Appl. No. 10/788,833
Amdt. dated 03/22/2005
Reply to Office action of 12/22/2004

Amendments to the Drawings:

REMARKS / ARGUMENTS

FIG. 6A

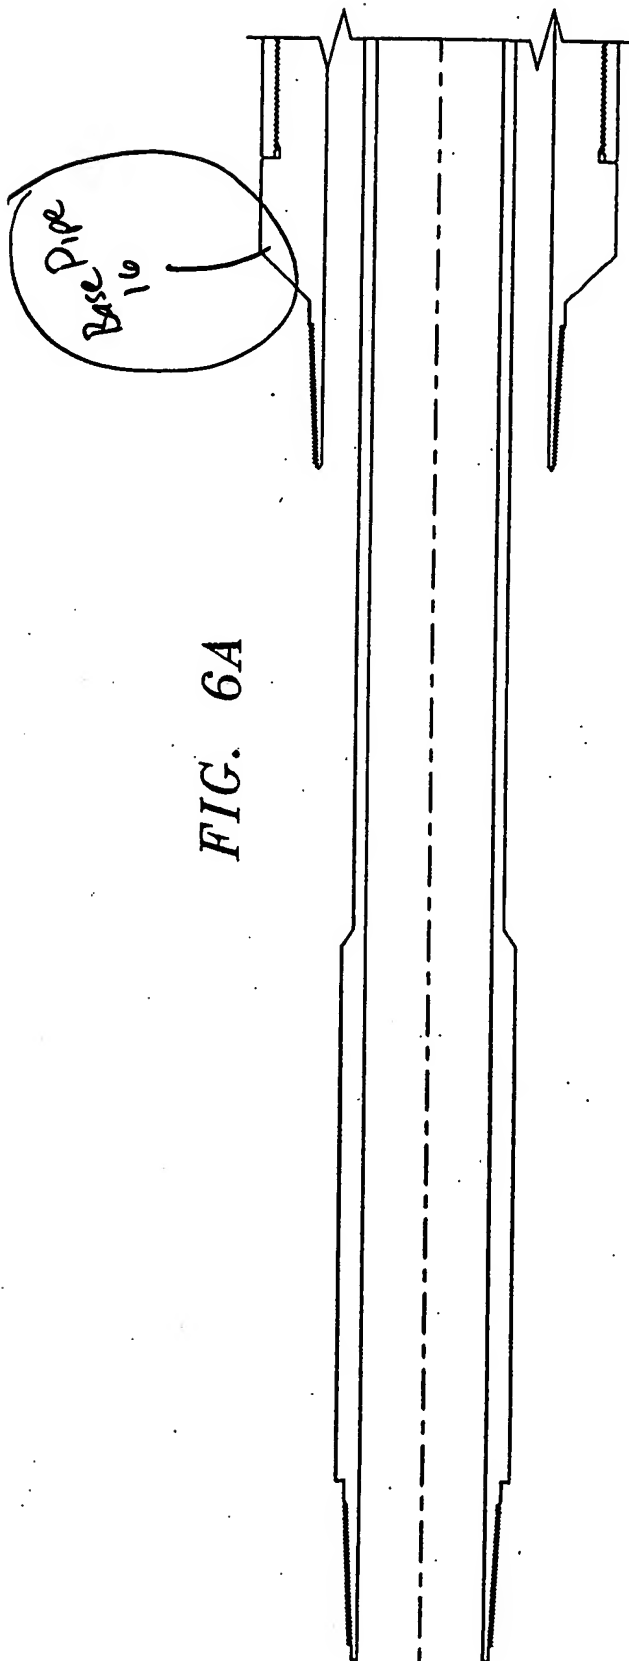
1. The drawings are objected to because the following figures do not include any reference numbers which are required for complete understanding of the claimed invention: 5A, 6A, 5E, 6E, 11C, and 12 G. Reference numbers should be added to the figures and, if not already found in the specification, added to the specification. A proposed drawing correction or corrected drawings are required in reply to the Office action to avoid abandonment of the application. The objection to the drawings will not be held in abeyance.

2. *The drawings are objected to because of the following informalities: Figures 5A-5E and 6A-6E are objected to because it appears that two drawing labels have been given to one figure, i.e. Figure 5A and 6A are the same figure. The examiner recognizes that applicant is attempting to show the different positions of the claimed invention but notes that each figure should be labeled as only one figure showing the change in position.*

Figures 5A, 6A, 5D and 6E have been amended by adding reference numerals. Support for these amendments may be found in, for example, paragraphs [0050] through [0052].

Applicant does not fully understand the substance of this objection or what corrective action the Examiner contemplates. Applicant contends that Figures 5A through 5E comprise partial views (in accordance with Rule 84(h)(2)) of a cross-sectional side view of a pressure actuated device (PAD) valve shown in an *open* configuration. Figures 6A through 6E comprise partial views (in accordance with Rule 84(h)(2)) of a cross-sectional side view of the PAD valve of Figures 5A through 5E shown in a *closed* configuration. These series of partial views are shown adjacent one another to better illustrate the structure and functioning of this particular embodiment of the invention. Applicant contends that no correction is necessary and no amendments to the drawings have been made in response to this objection.
